Southern California Edison
A.21-08-009 – TLRR CSP PTC

DATA REQUEST SET C P U C - S C E - 0 0 3

**Highway 168 Alternative-Proposed Project
Scope Comparison**

Figure 1

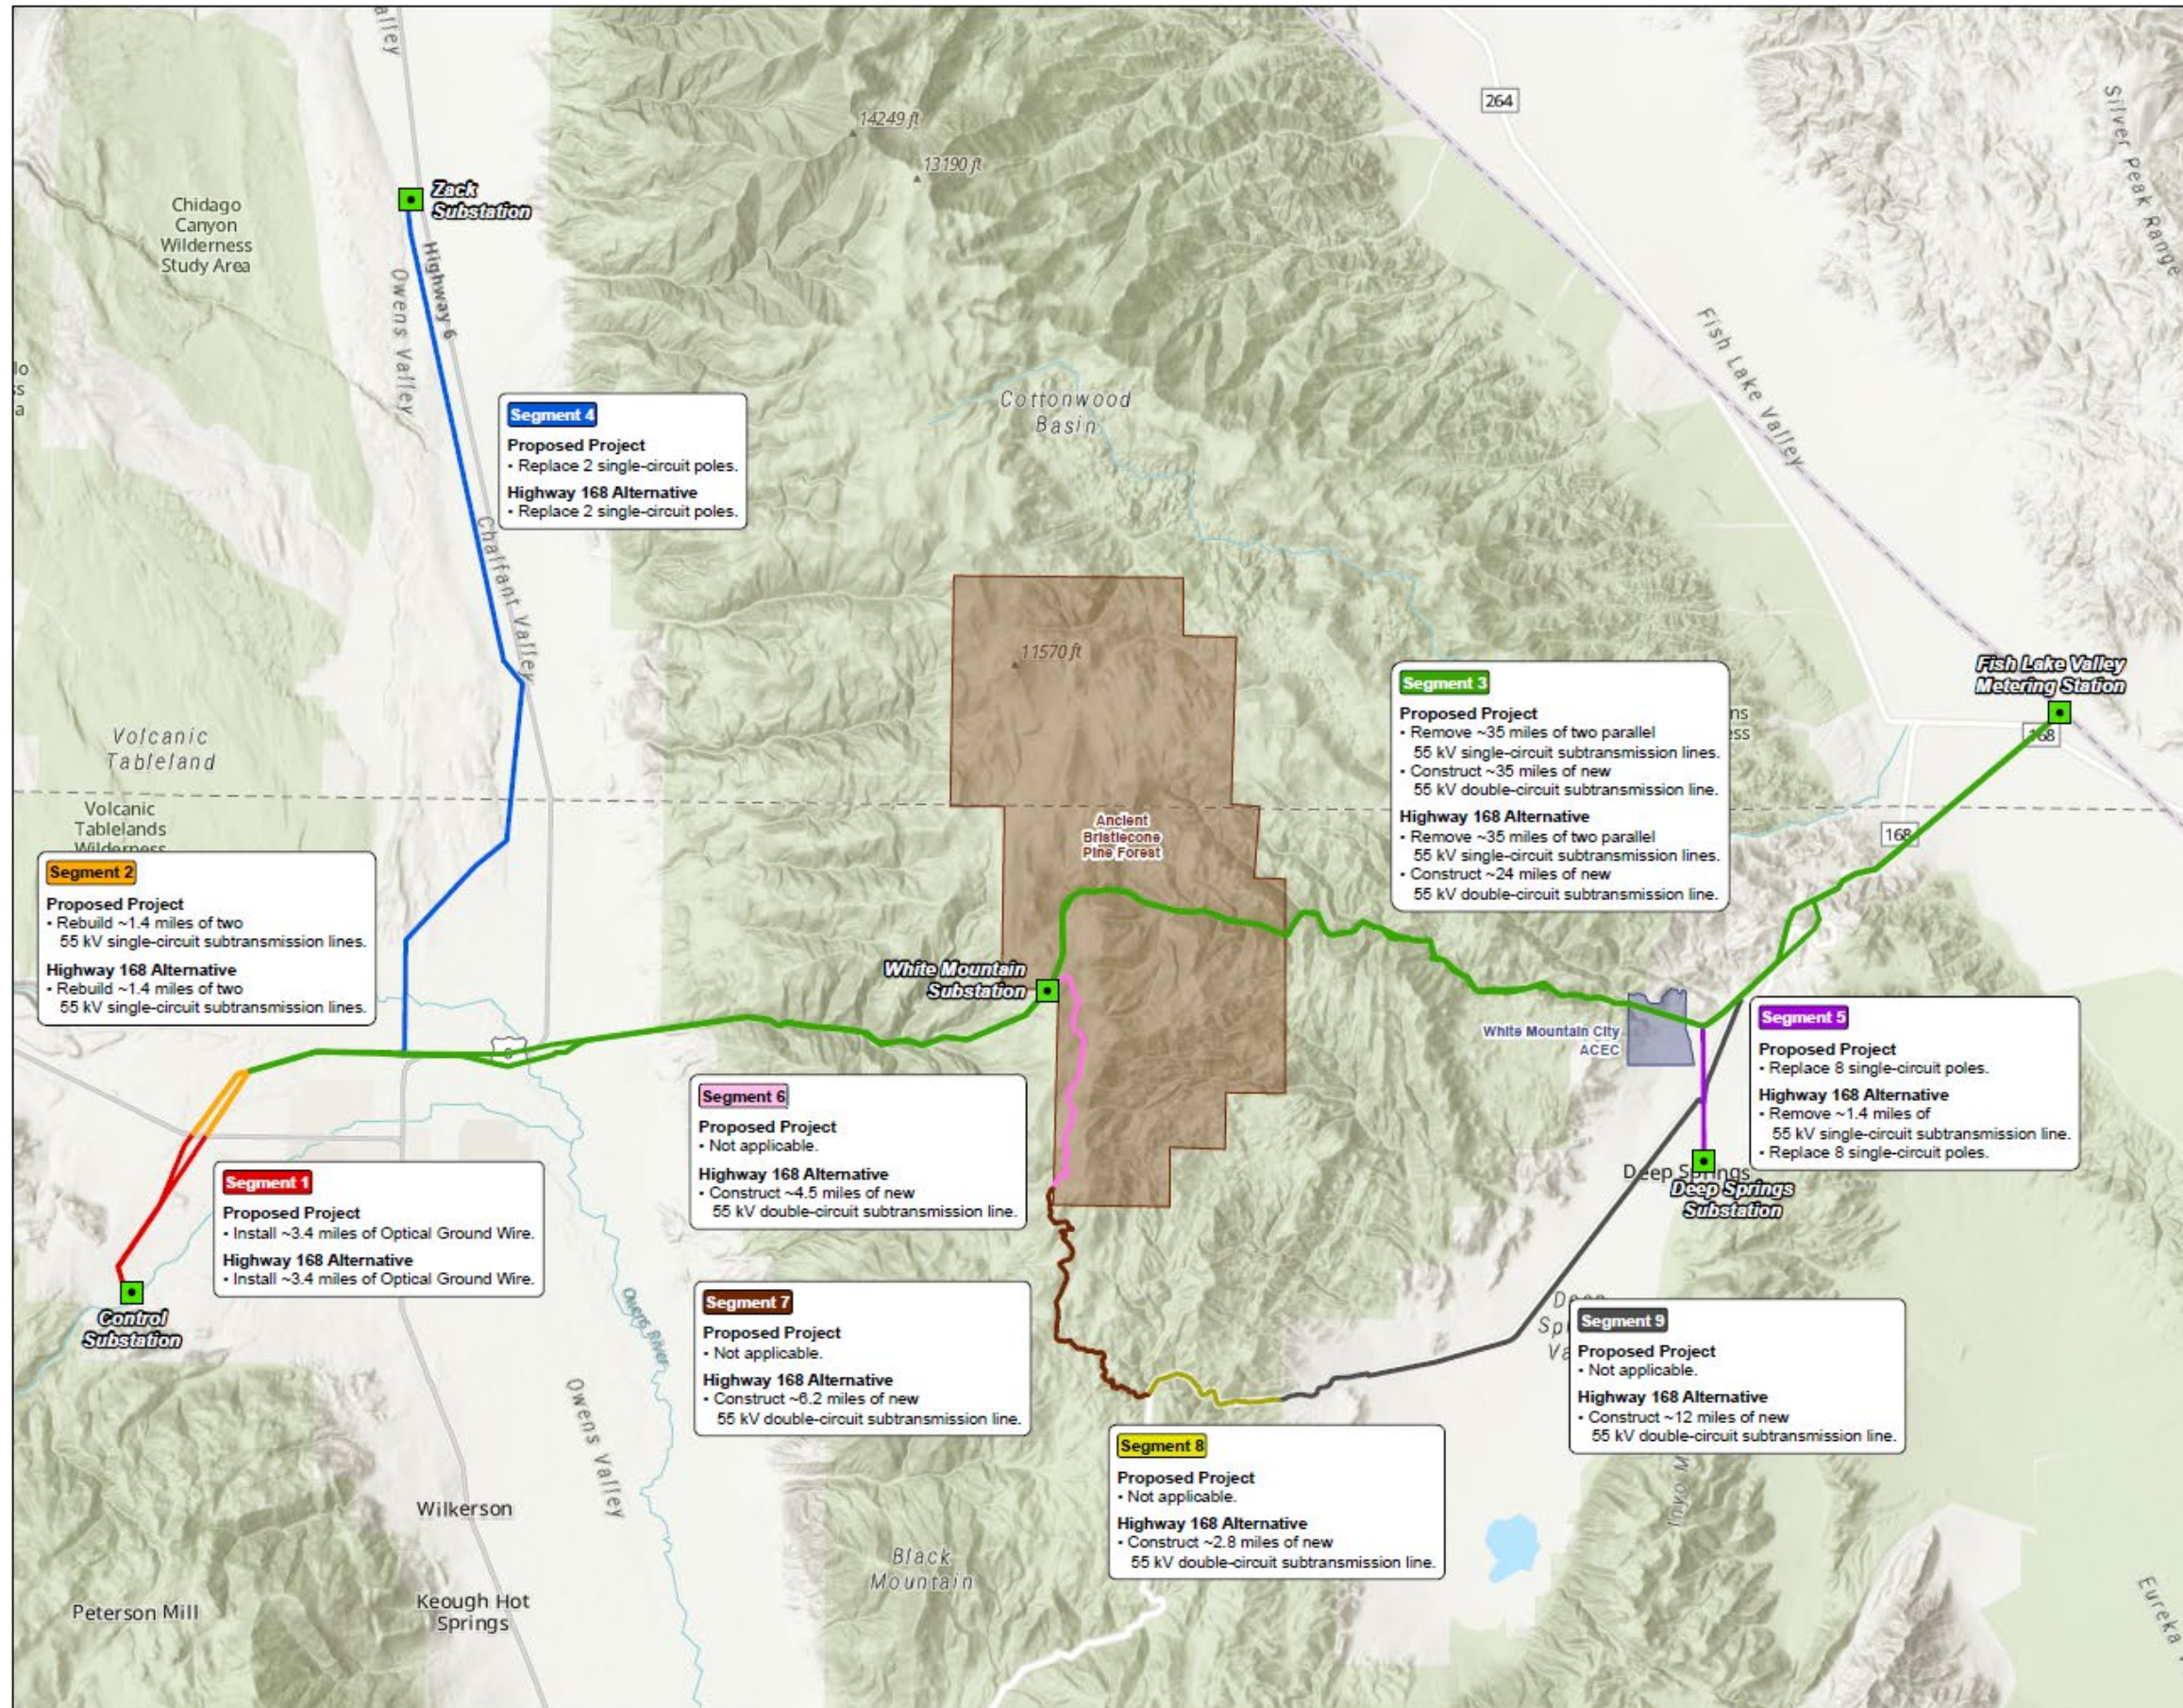
Please provide any comments regarding feasibility, ability to meet most project objectives, and other potential constraints for the route depicted on the figure (attached). As shown, the route would generally follow White Mountain Road and then Highway 168 before reconnecting with the existing subtransmission line toward the Fish Lake Valley Metering Station.

Southern California Edison (SCE) has reviewed and evaluated the Highway 168 Alternative Route (“Alternative”) referenced in *Southern California Edison’s Control-Silver Peak Project (A.21-08-009) – CPUC-SCE-003*. SCE has prepared a desktop-level environmental analysis to assess whether the Alternative is feasible and could meet project objectives, and to identify any potential constraints. The analysis is attached to this data request response, titled “CPUC-SCE-003 Attachment” and concludes that the Alternative appears to be both feasible and able to meet all project objectives.

The work scope between Control Substation and White Mountain Substation would remain the same for the Alternative as the Proposed Project¹. Similarly, under either the Proposed Project or the Alternative, SCE must continue to supply power to the communications sites along the summit of White Mountain Road. However, after approximately 1,000 feet beyond White Mountain Substation, instead of continuing eastward towards Wyman Canyon, the Alternative would route the lines south and follow White Mountain Road (past the Inyo National Forest Visitor Center at Schulman Grove) and Forest Service Road 35E313 for approximately 8 miles to intersect with Highway 168. From the intersection with Highway 168, the lines would turn eastward for approximately 15 miles, to a location where Highway 168 intersects with the Proposed Project. From that intersection and continuing eastward for the remaining approximately 8 miles to the Fish Lake Valley Metering Station, the work scope for the Alternative would again be the same as the Proposed Project².

The Alternative would permanently remove approximately 15 miles of existing lines between the White Mountain Substation and the new intersection point, including all structures and wires within Wyman Canyon, a portion of the identified bi-state sage grouse habitat, and the White Mountain City ACEC. (Note: The overall scope of the Proposed Project also requires removal of these same facilities, so any previously-identified temporary construction impacts associated with removal efforts in those areas will be the same under both the Proposed Project and the Alternative.)

Substation and the Fish Lake Metering Station, however, that additional distance *does not* trigger the need to increase the system voltage from 55kV to 115kV, therefore no additional substations would be needed. There would be approximately 275-300 additional poles installed for the Alternative when compared to the Proposed Project, as well as approximately 100-150 acres of additional temporary disturbance associated with these poles, though SCE cannot provide a specific breakdown of quantities and structure types and more precise disturbance areas similar to the formatting found in PEA Tables 3.3-2 and 3.3-3 until a preliminary engineering design is completed.

SCE has prepared a desktop-level environmental analysis, separately attached to this data request, that more fully details the Alternative's feasibility, ability to meet most project objectives, and other potential constraints. Through this initial desktop evaluation of the Alternative, SCE has identified that while the Alternative could reduce potential aggregate impacts to some environmental resources, it could also trigger potentially significant impacts to other environmental resources. The attachment provides a summarized comparative analysis of the anticipated impacts of both SCE's Proposed Project and the Alternative.³ The analysis assumes a conventional overhead configuration (i.e., a subtransmission line constructed from a combination of monopoles, H-frames, and aerial conductor), similar to the design configuration used for the Proposed Project.
